AGENDA
CASCADE CHARTER TOWNSHIP PLANNING COMMISSION
MONDAY, MAY 6, 2024
7:00 PM
2870 JACKSMITH AVE SE

PLANNING COMMISSION STAFF REPORT

STAFF REPORT: Case #23-3804
REPORT DATE: April 24, 2024
PREPARED FOR: Cascade Charter Township Planning Commission
MEETING DATE: May 6, 2024
PREPARED BY: Andrea Hendrick, Planning Director

REQUESTED ACTION: Site Plan Review for a new office building.

1. Dumpster Enclosure Plan

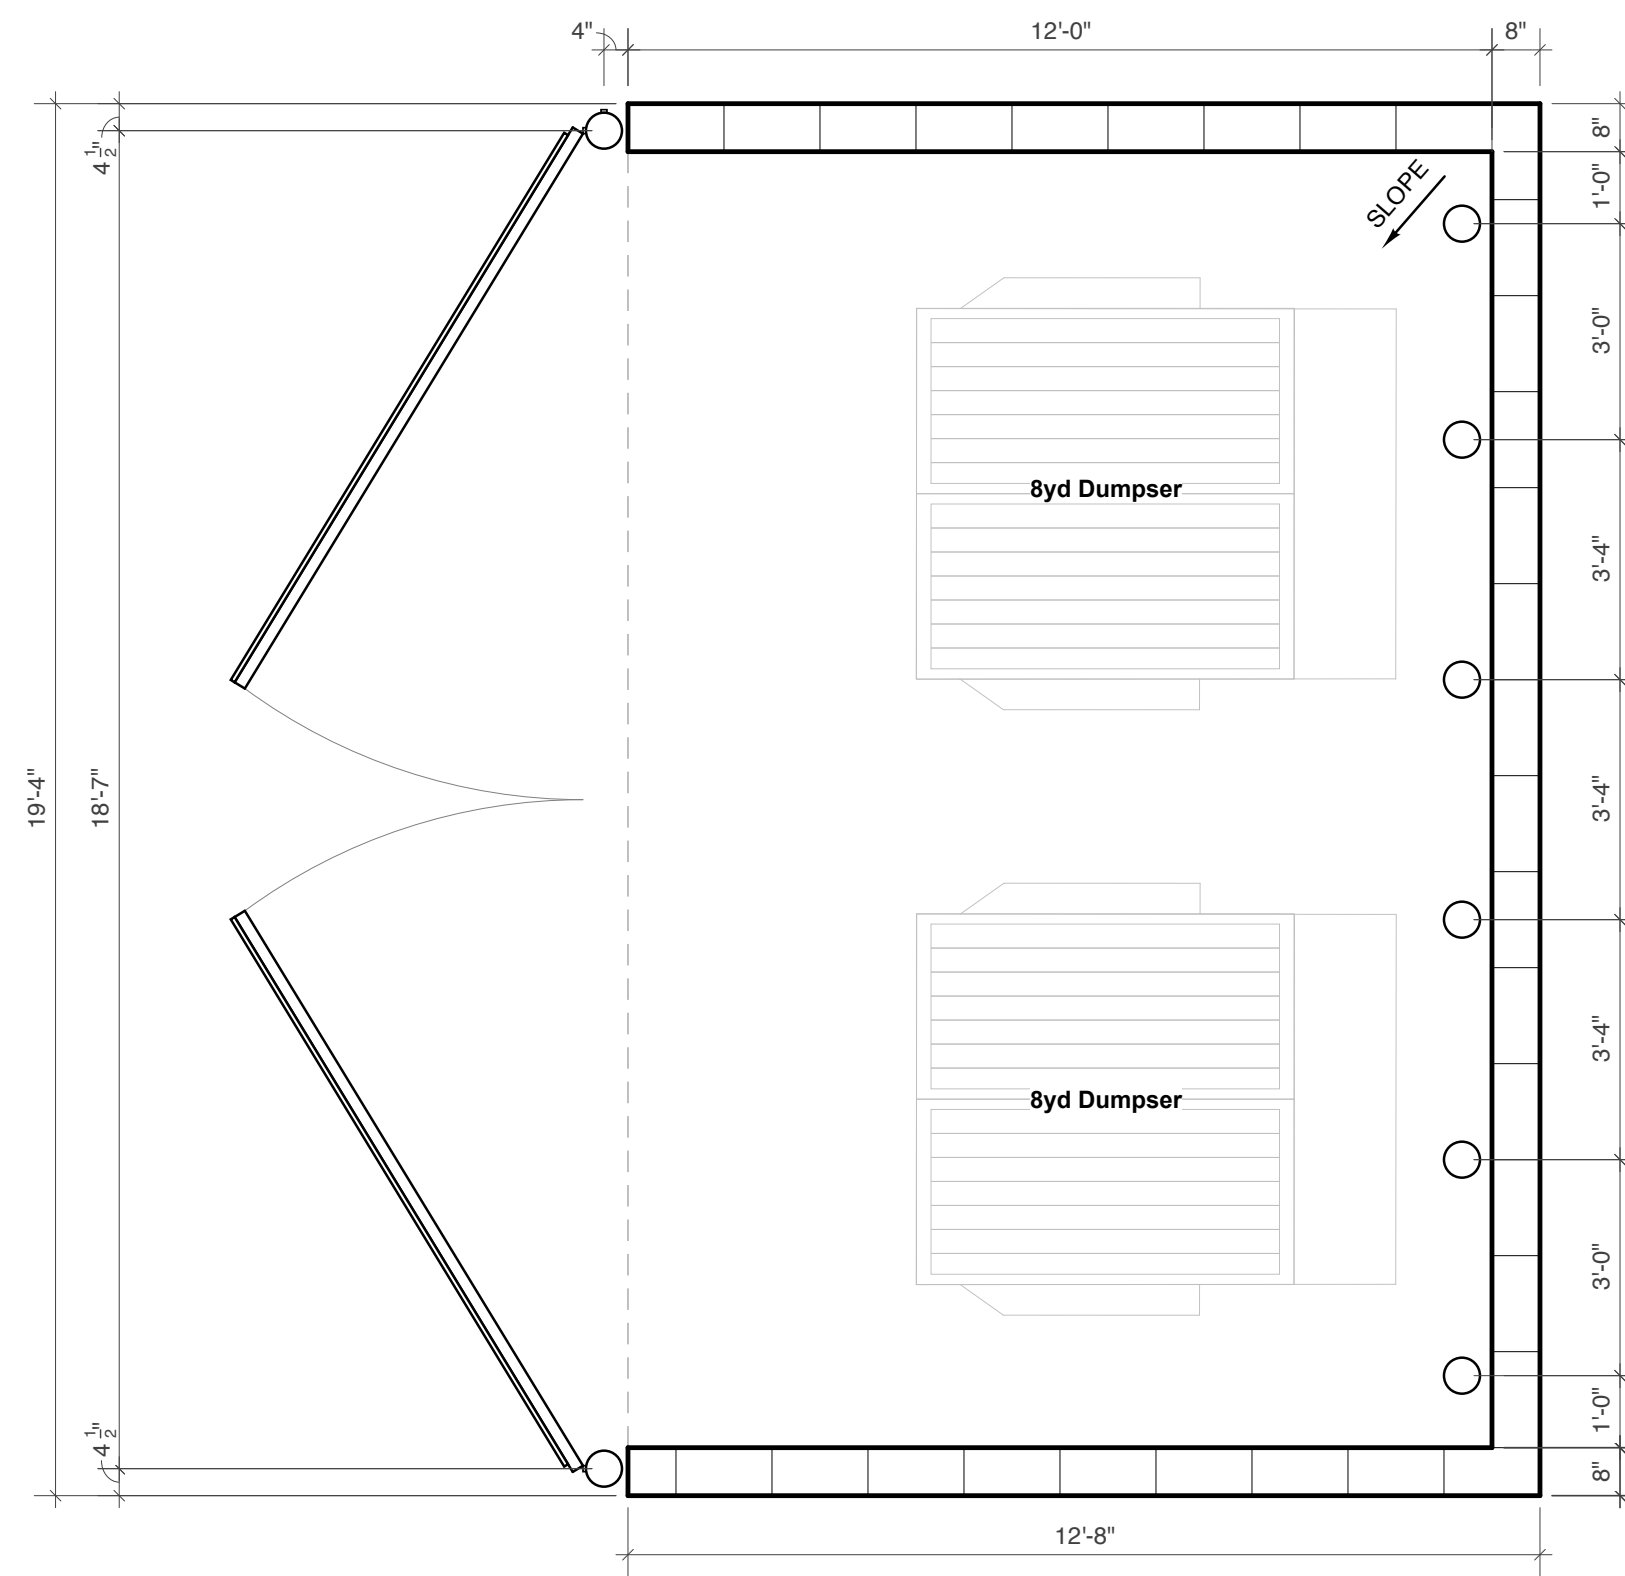
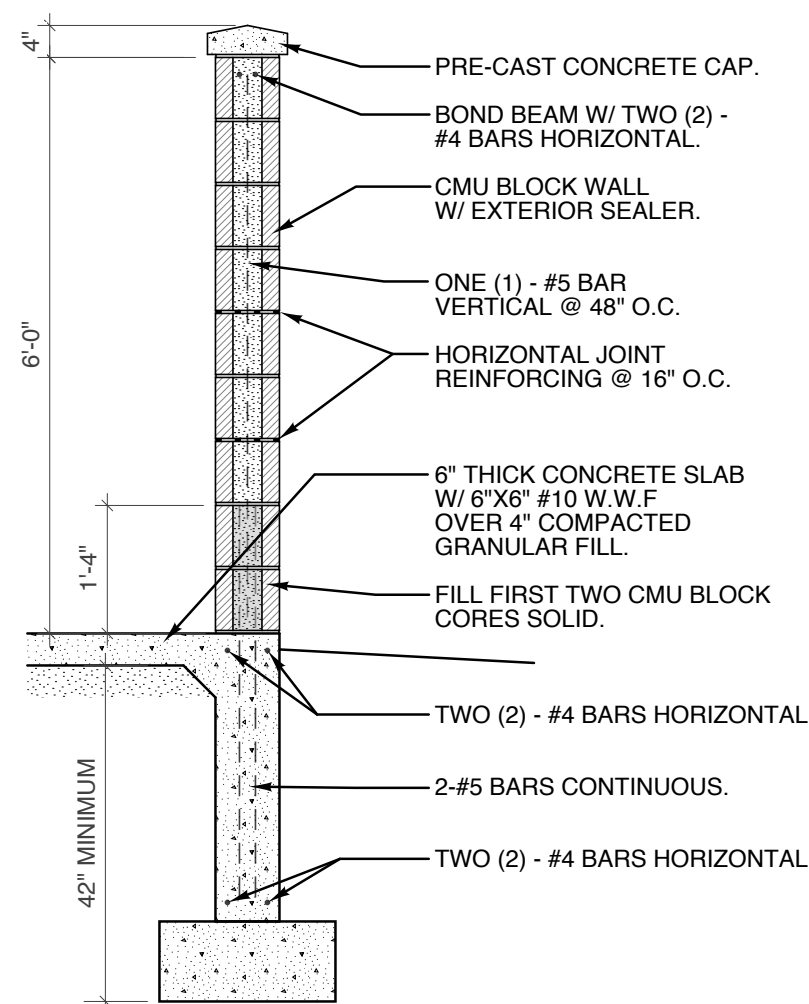
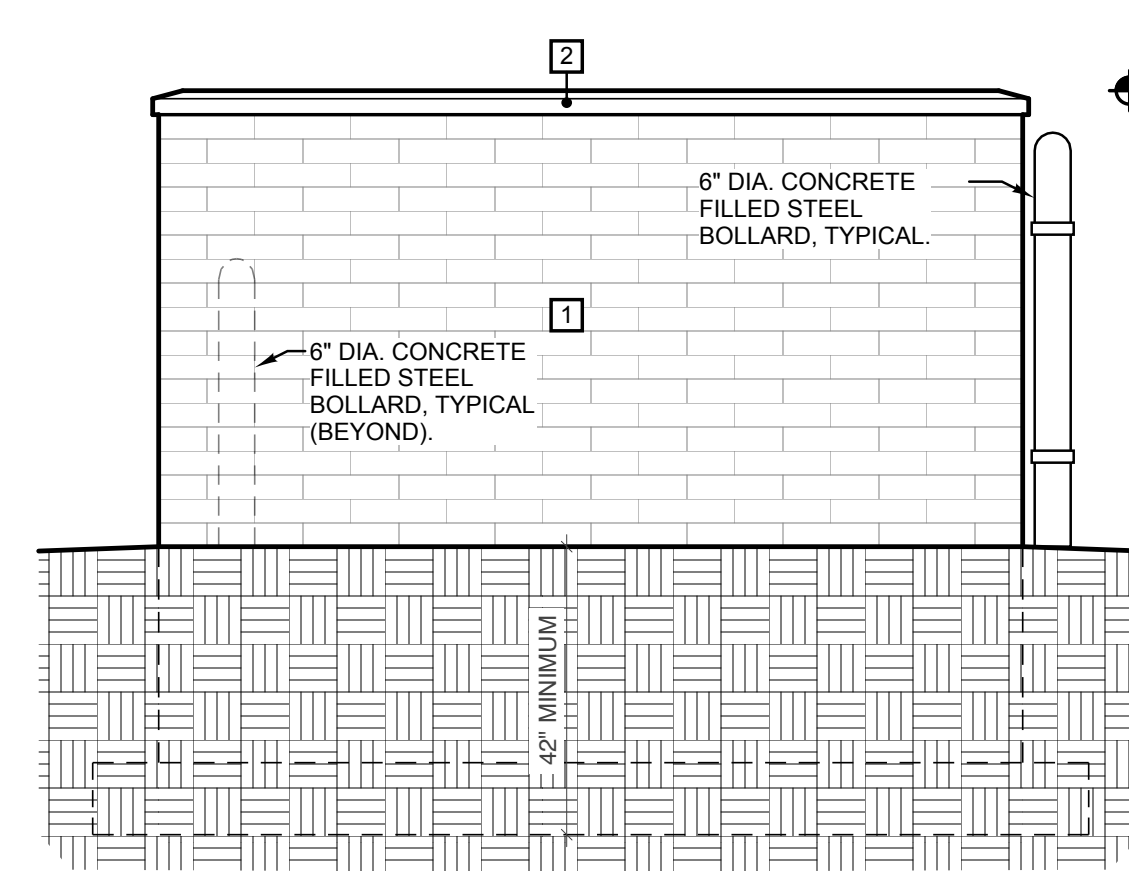
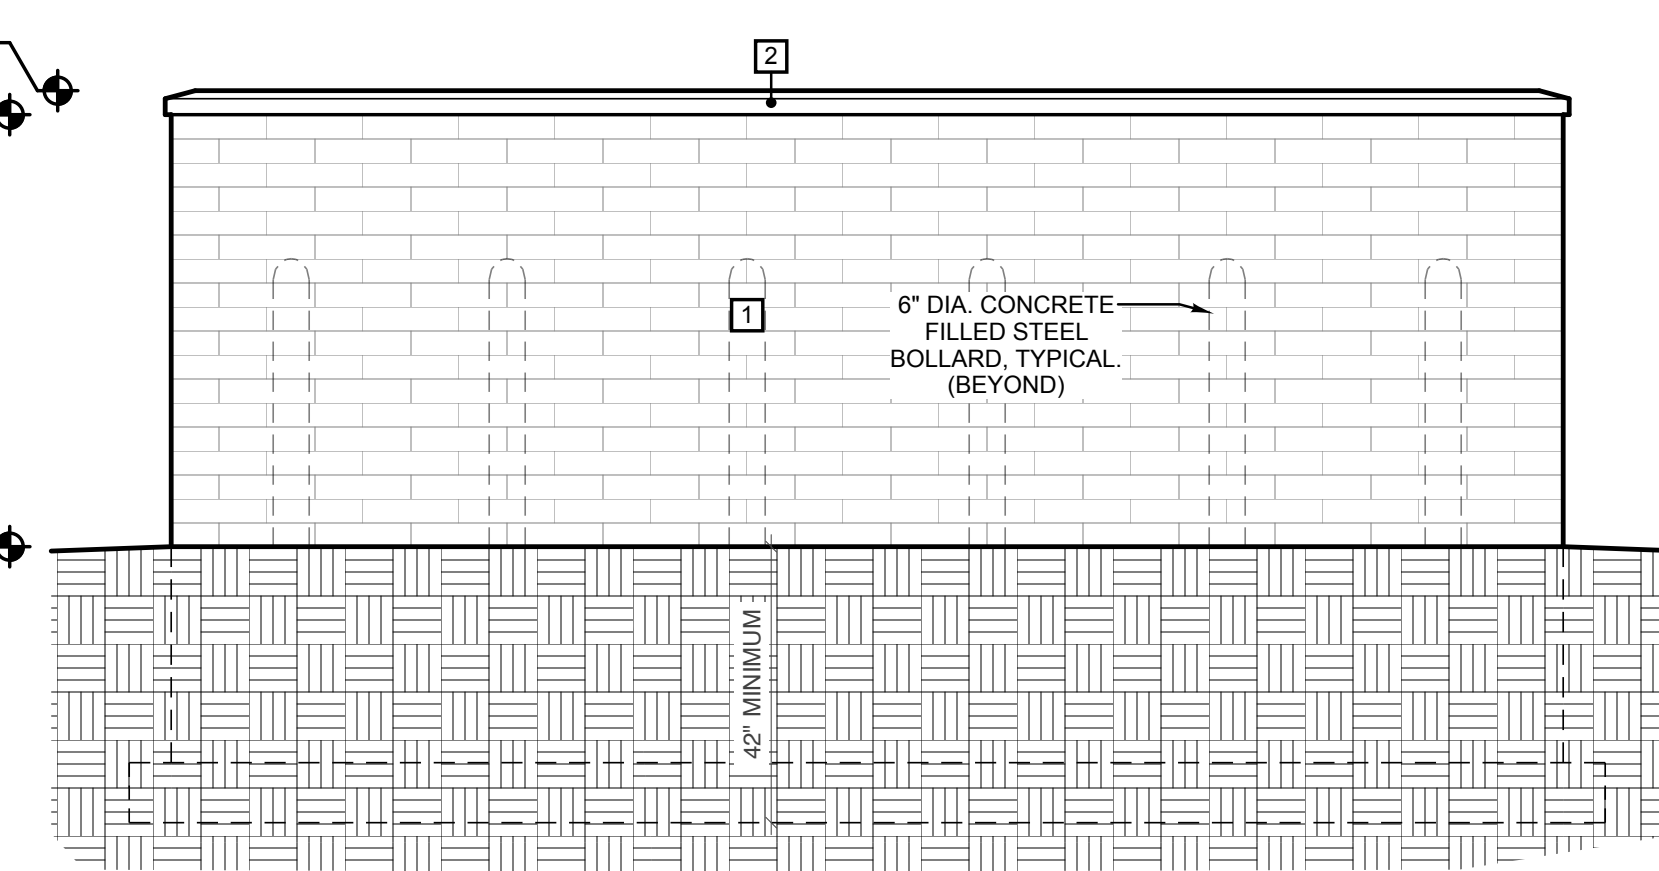
15. Chain link fence shall be prohibited.	No chain link fence is proposed. The standard is met.
16. Dumpsters shall be located in the rear yard or side yard and must be screened. These facilities shall be enclosed with a solid fence or wall six (6) feet high with solid doors having sufficient truck access for dumpster service.	The dumpster is in the rear (south) side behind the parking lot. A twelve (12) foot by nineteen (19) foot brick dumpster enclosure with solid doors is on the plans. The door is Faux Wood Siding over Steel Frame. The height of the enclosure is six (6) feet. The standard is met.

2. North Elevation

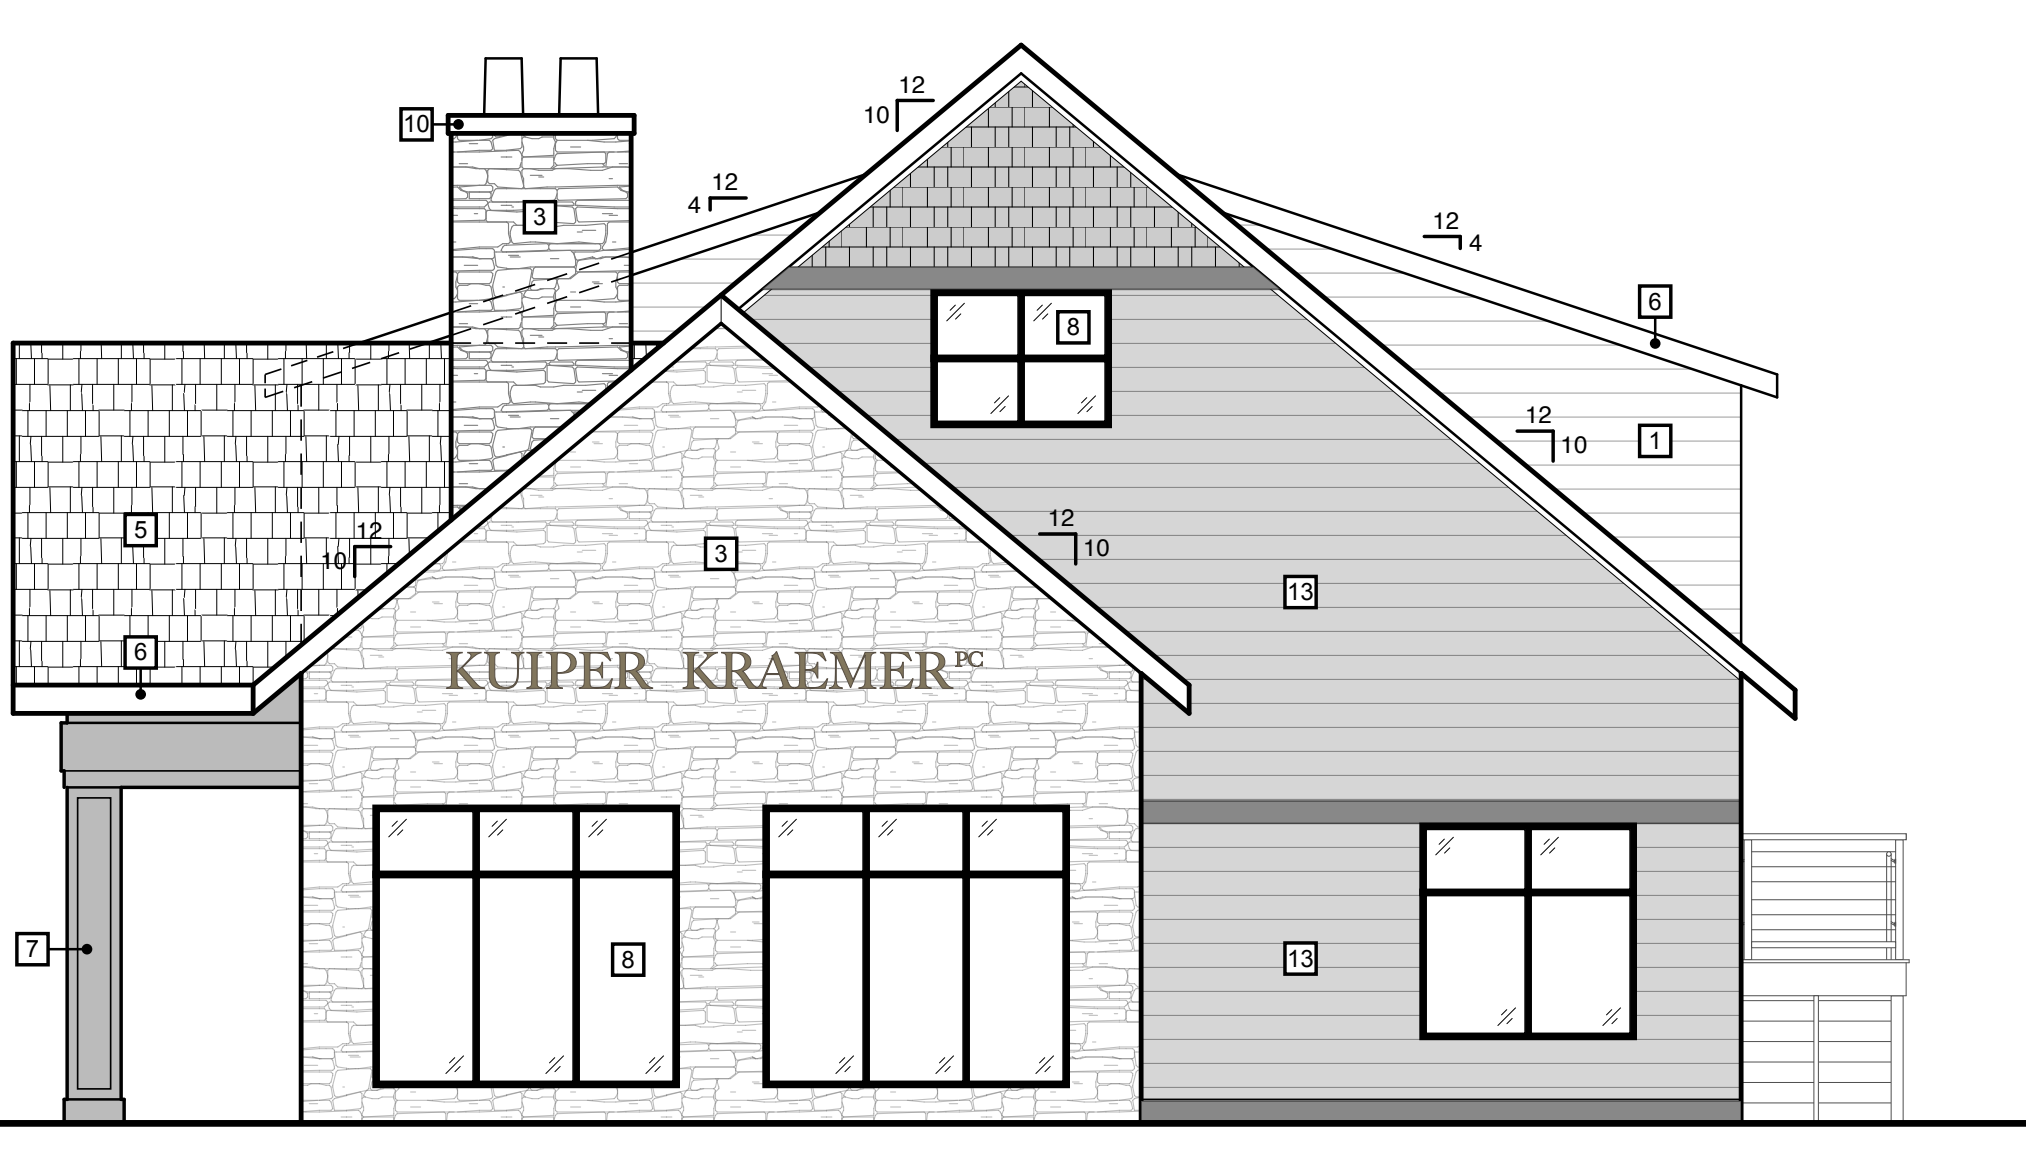
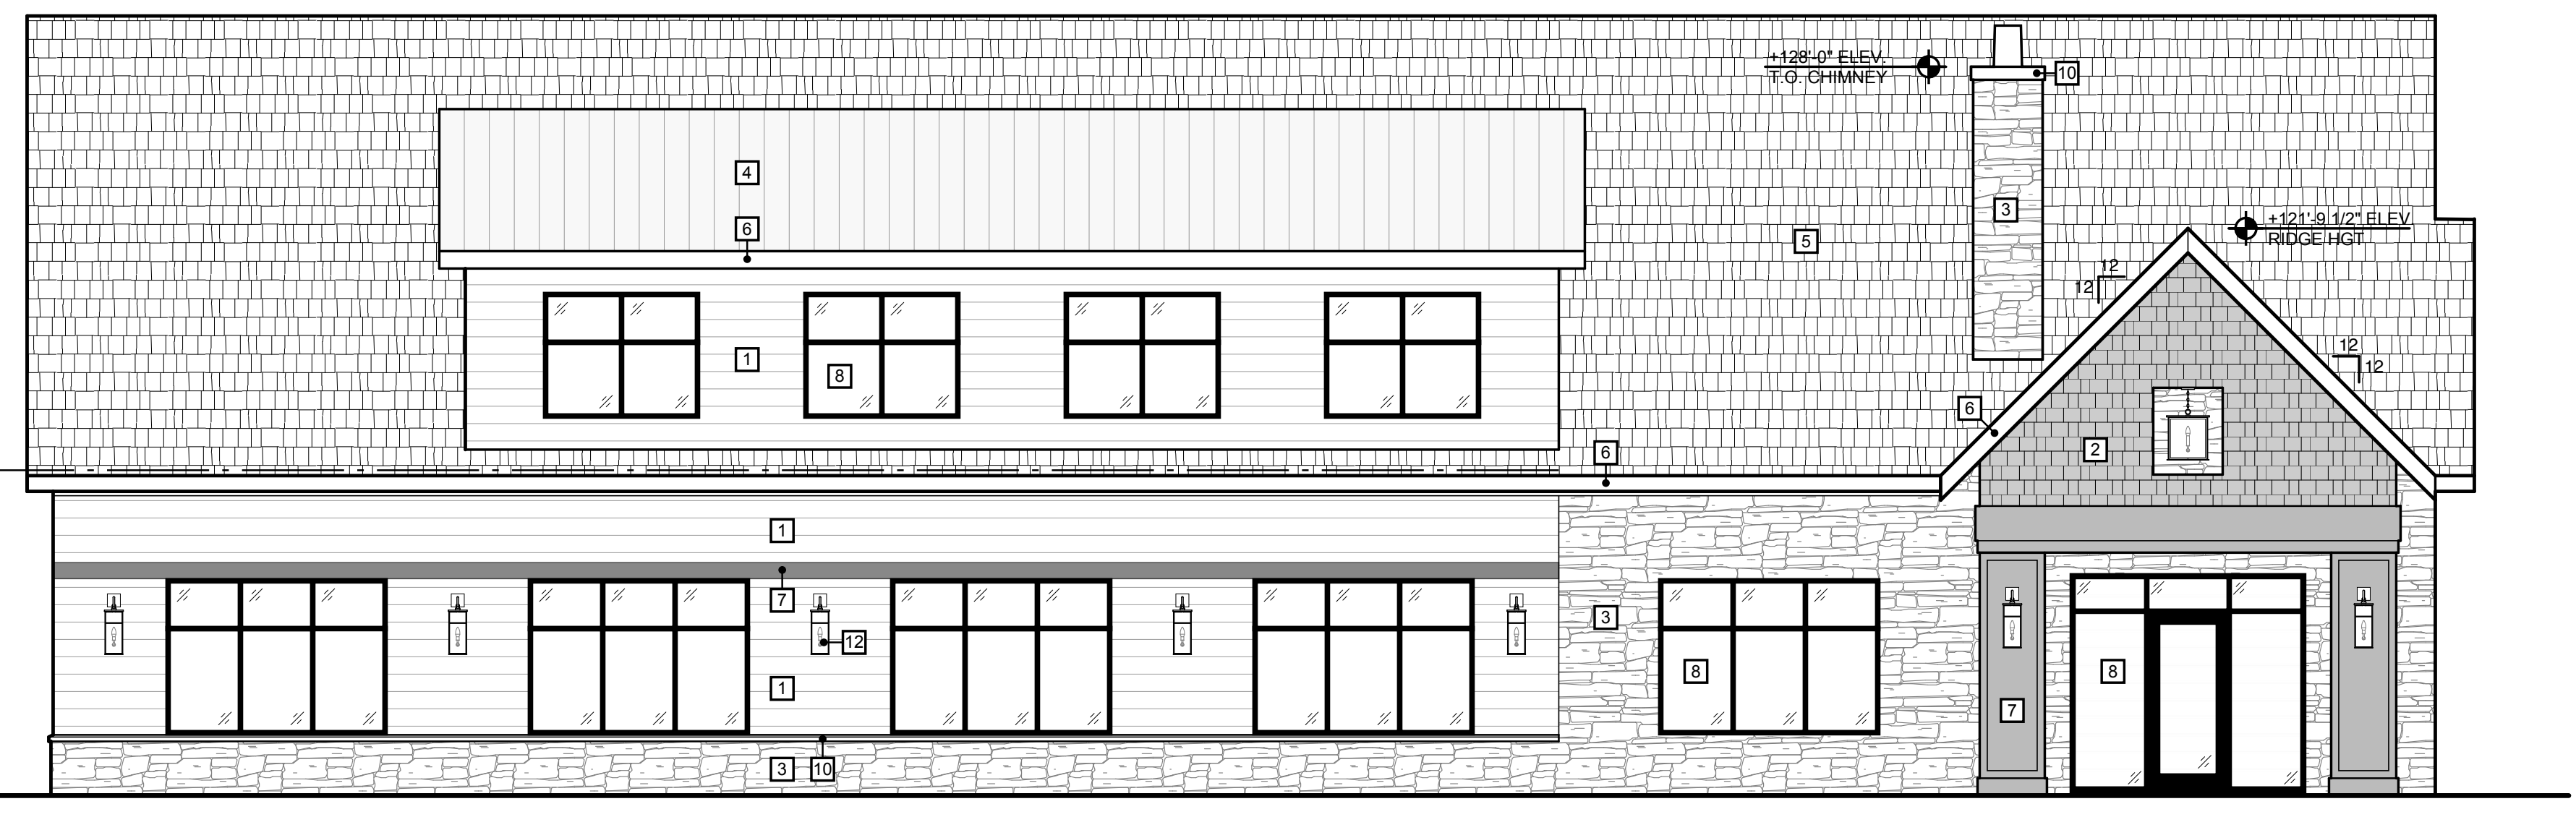
2. The applicant has provided high quality materials on all sides. However, the proposed design does not extend the stone veneer material provided on the base of the east and south side, onto the west side of the building. After reviewing the site’s conditions, it was determined that natural features on the west side provide extensive screening for this side of the building. Existing natural features include a wooded area on site that is to be preserved, along with a steep gradient starting on the west side of the subject property and climbing westward onto the adjacent property. The VDRC found that the extension of the stone veneer was unnecessary, and relaxation of these standards would have no detrimental impact on surrounding neighbors or the overall character of the district. The VDRC recommends approval.

<p>4. At least 90% of the exterior finish material on all facades shall be limited to the following: glass; brick; stone; stucco; or wood.</p>	<p>Proposed in the Exterior Materials Legend on page A4.1 of the site plan are the following finishes:</p> <p>Front: Stone Veneer, Cement Board Lap Siding (amended in updated rendering), glass windows that measure roughly eight (8) feet by eight (8) feet, and accented with Cement Board Shake Siding.</p> <p>West: Cement Board Lap Siding and Stone Veneer, with five (5) large glass windows, six (6) feet by six (6) feet. The porch is Cement Board Shake Siding with Fiber Cement Trims.</p> <p>East: Six (6) large windows that measure roughly eight (8) feet by six (6) feet, and all Cement Board Lap Siding for the finish.</p> <p>Rear: Cement Board Lap Siding and Stone Veneer with four (4) doors (one at the mezzanine level) and two windows.</p> <p>All proposed exterior finish material indicated as Cement Board Lap siding does not appear to be consistent with this standards material requirements. The stone is in line with the standards.</p>
